## ADDENDUM NO. 1

December 8, 2025

TANG HALL LABORATORY  
FIT-OUT

**A-721R**

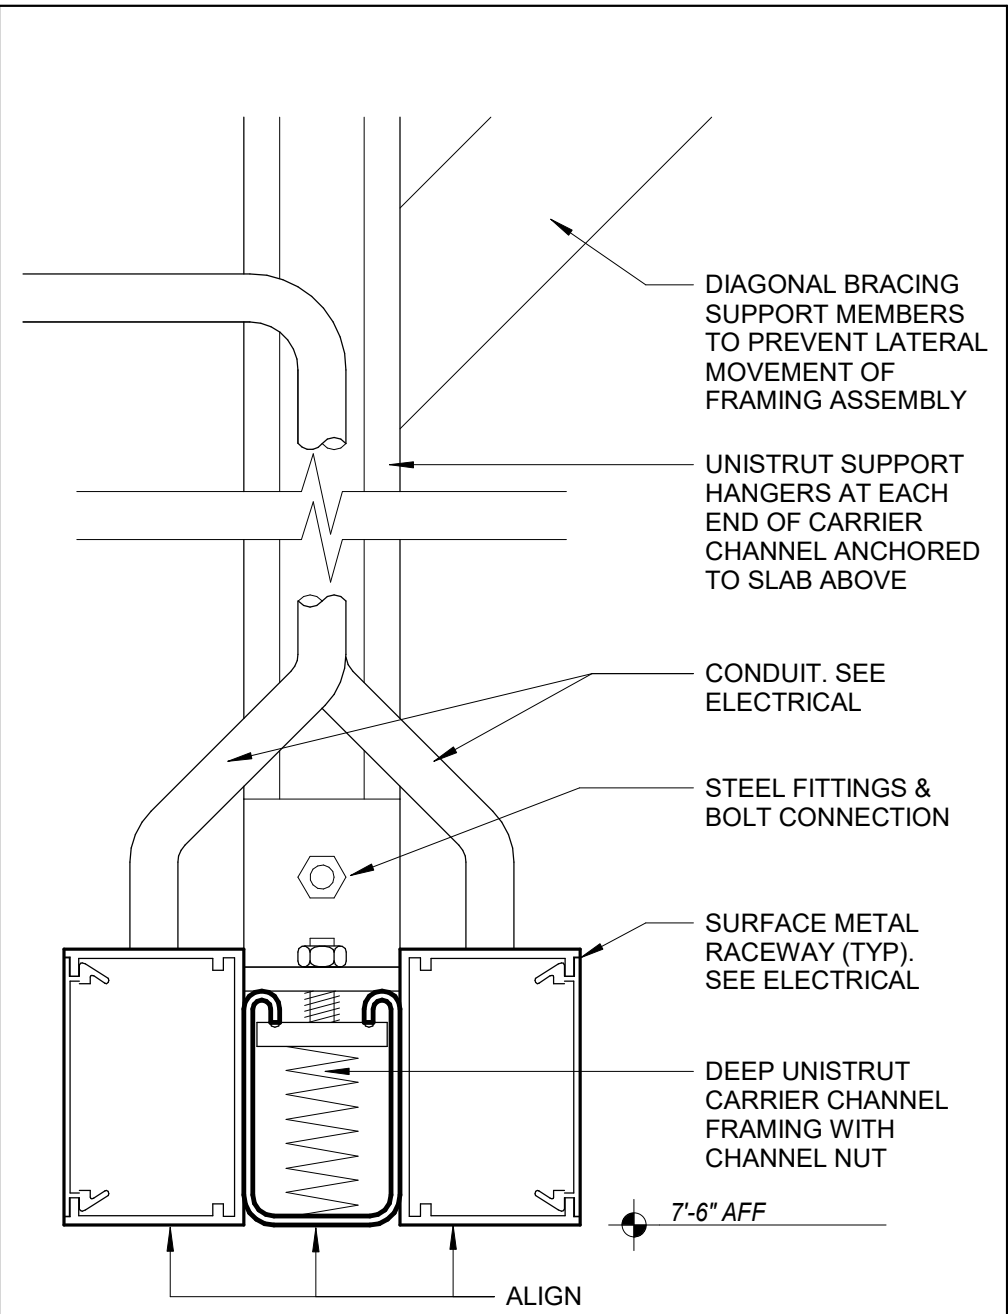
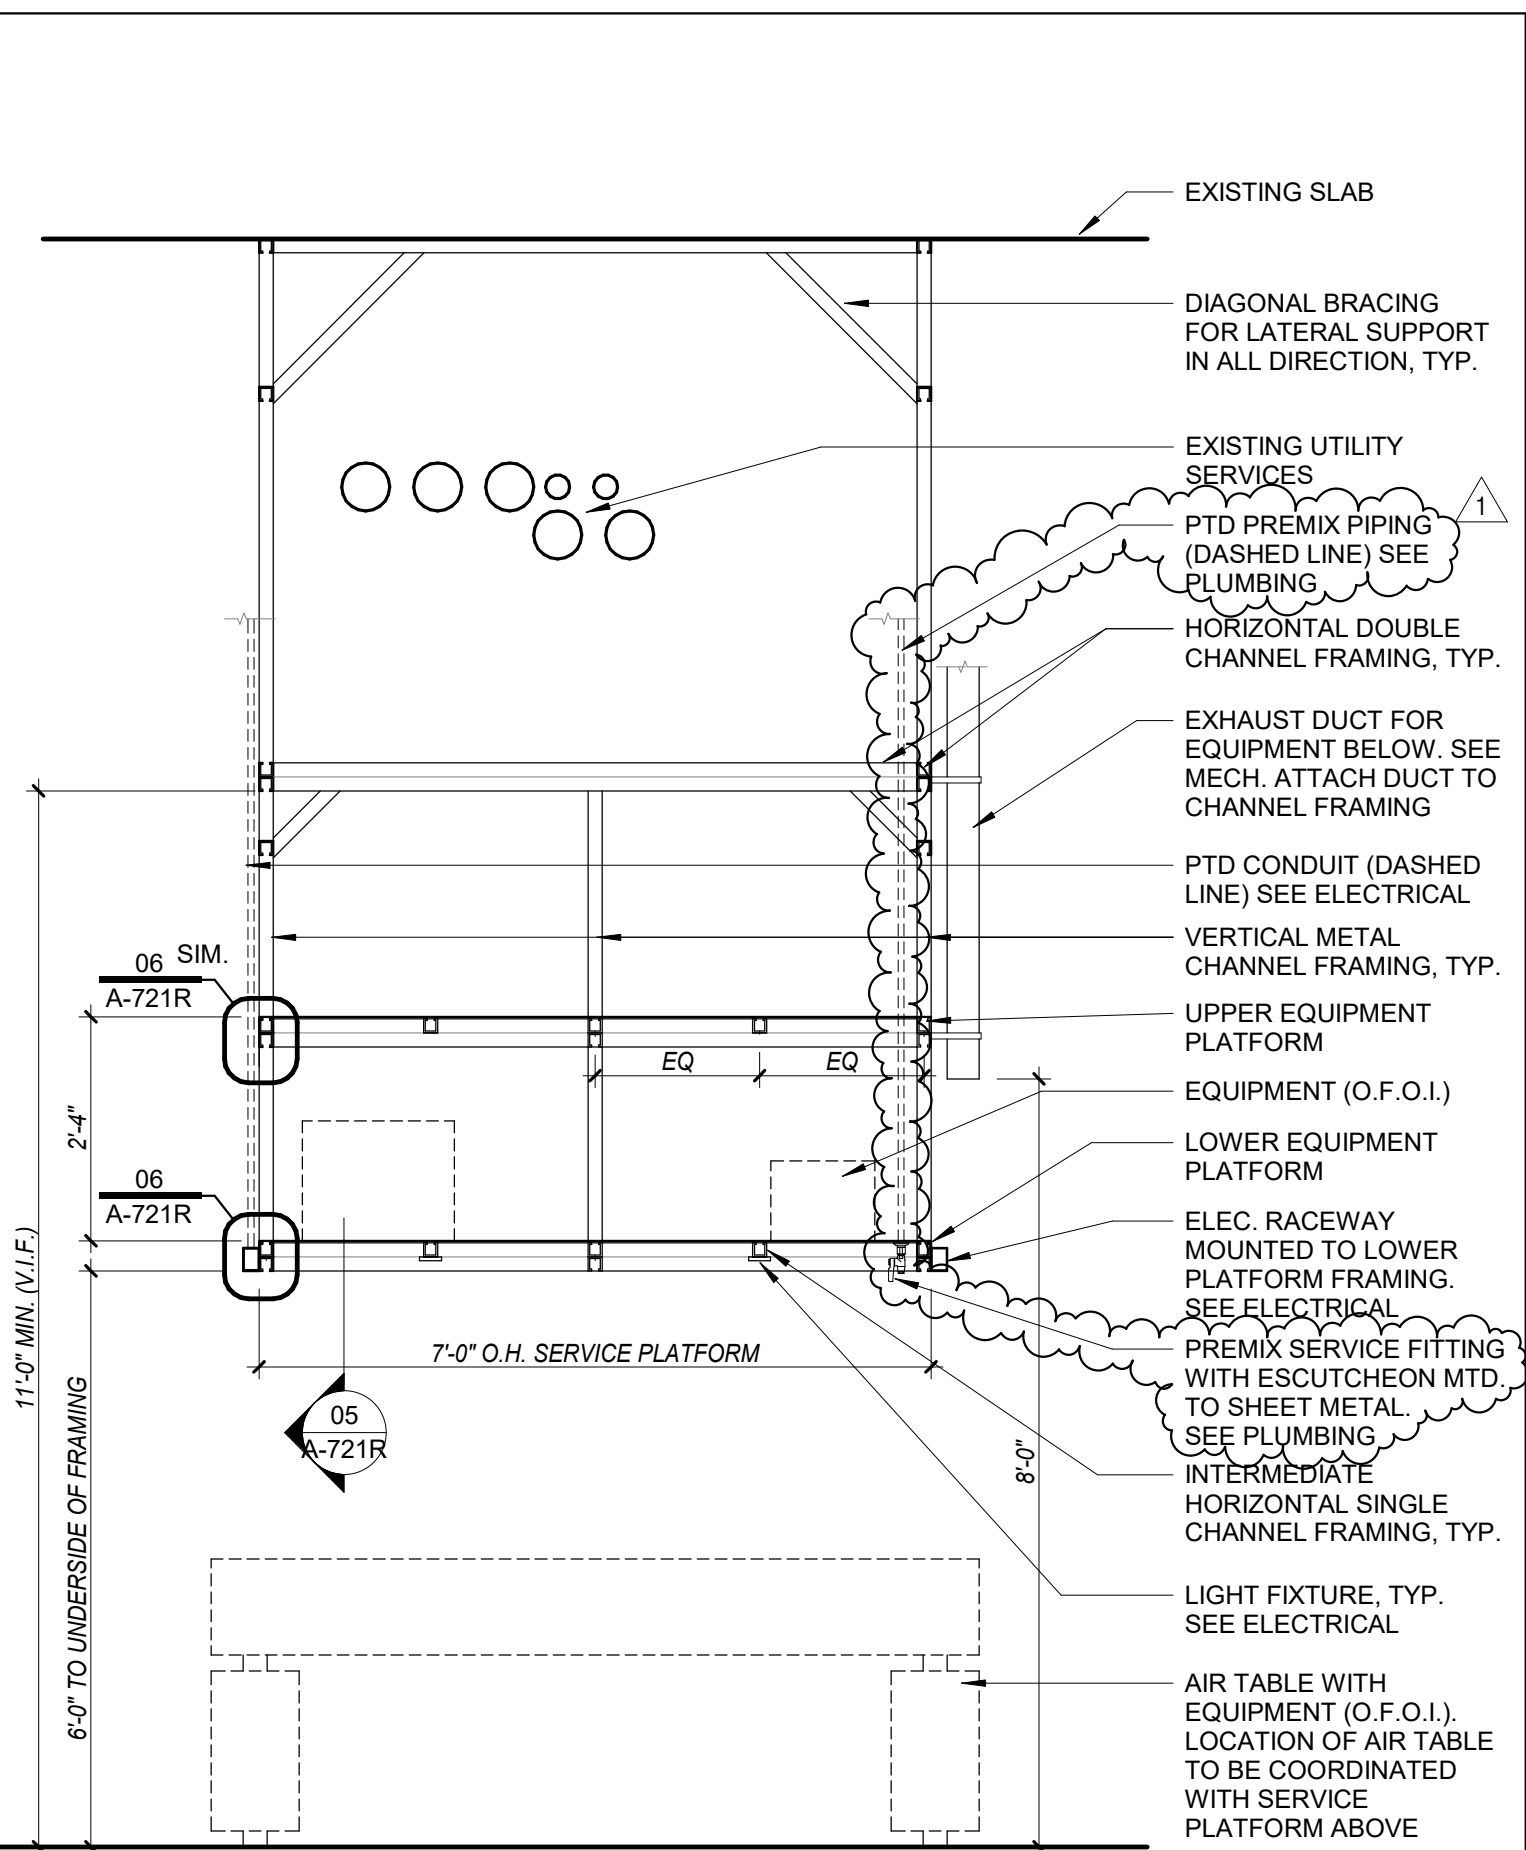
Item 8. Drawing A-721 - Miscellaneous Details, Overhead service platform detail

Added the premix gas turret at the overhead service platform to serve the equipment below.  
See Item 13 for description.

**REPLACE** with revised Drawing A-721R, attached.

# A-900R

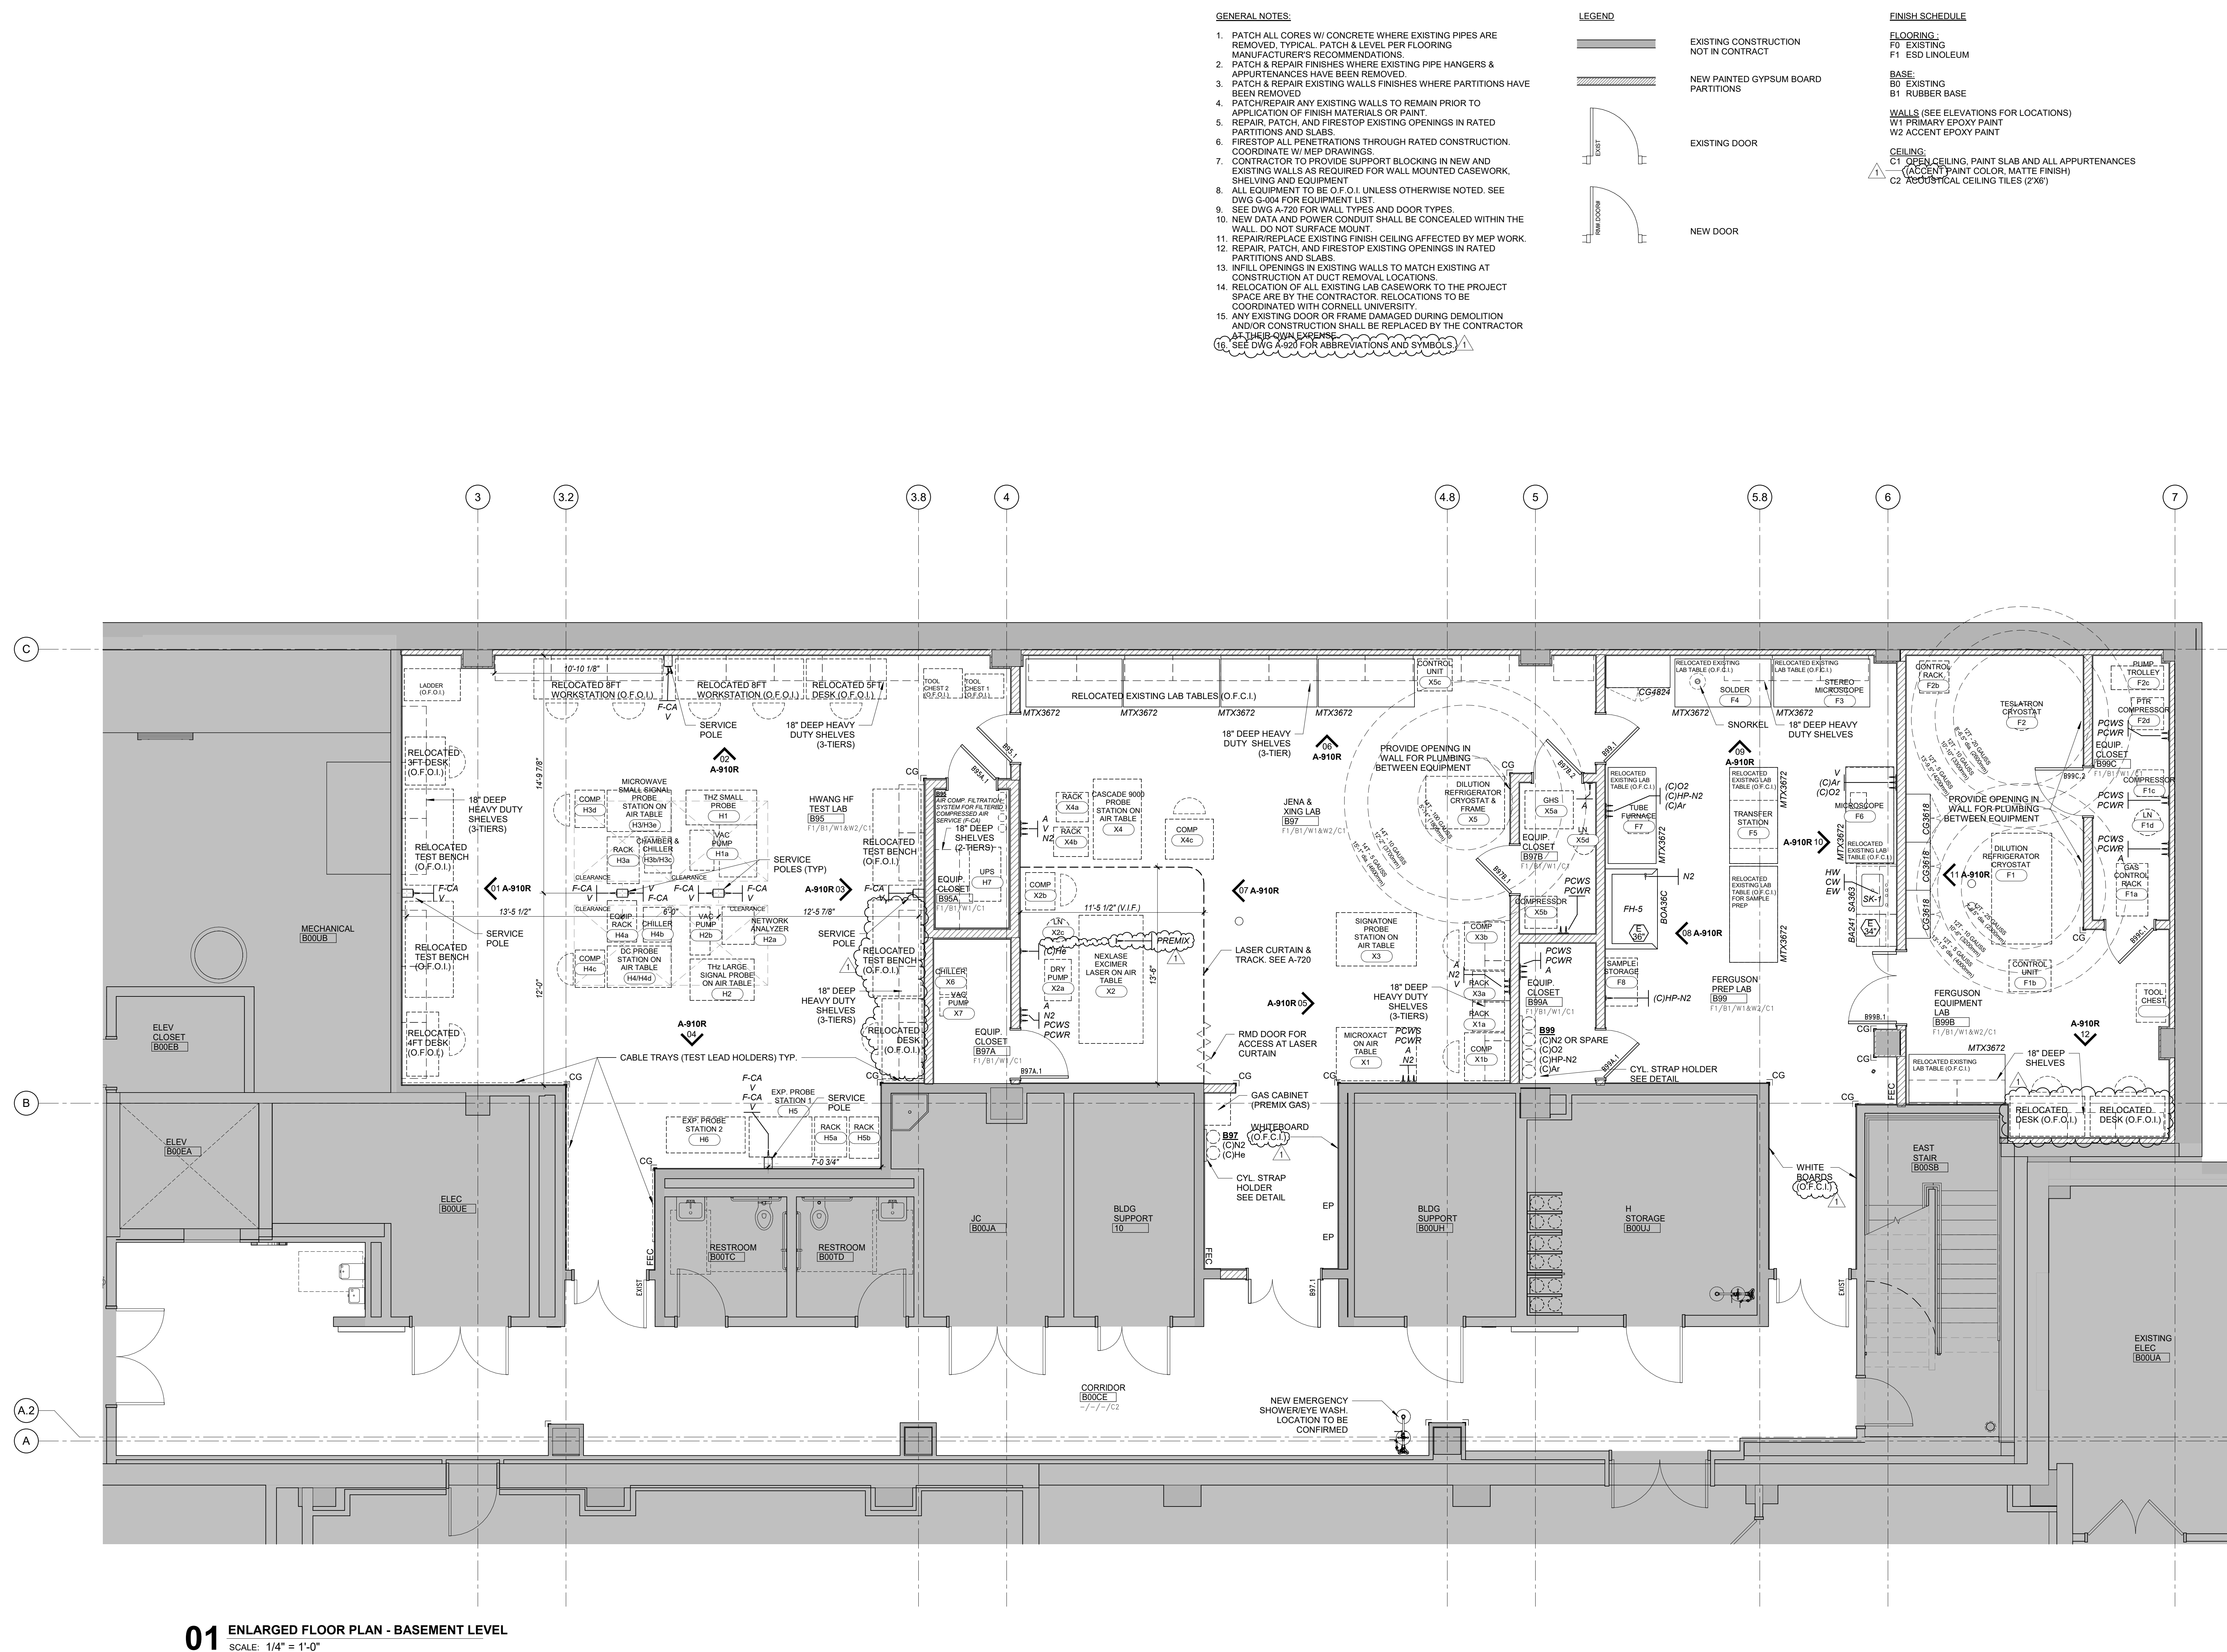
Item 10. Drawing A-900R, at Lab B95:

Revised new 3’x6’ Test Bench and new 5ft Desk to **“Owner furnished, owner installed test bench and desk.”**

Item 11. Drawing A-900R, Plan at Lab B99

**DELETE** two new desks

Item 12. Drawing A-900R, at Labs B97 & B99

**DELETE** new whiteboards

Item 13. Drawing A-900R, at Lab B97

**DELETE** the premix gas service at wall

**ADD** the premix gas turret at overhead service platform.

**REPLACE** with **“Owner furnished, Owner installed desks”**

**REPLACE** with **“O.F.C.I. (Owner furnished, Contractor installed) whiteboards”**
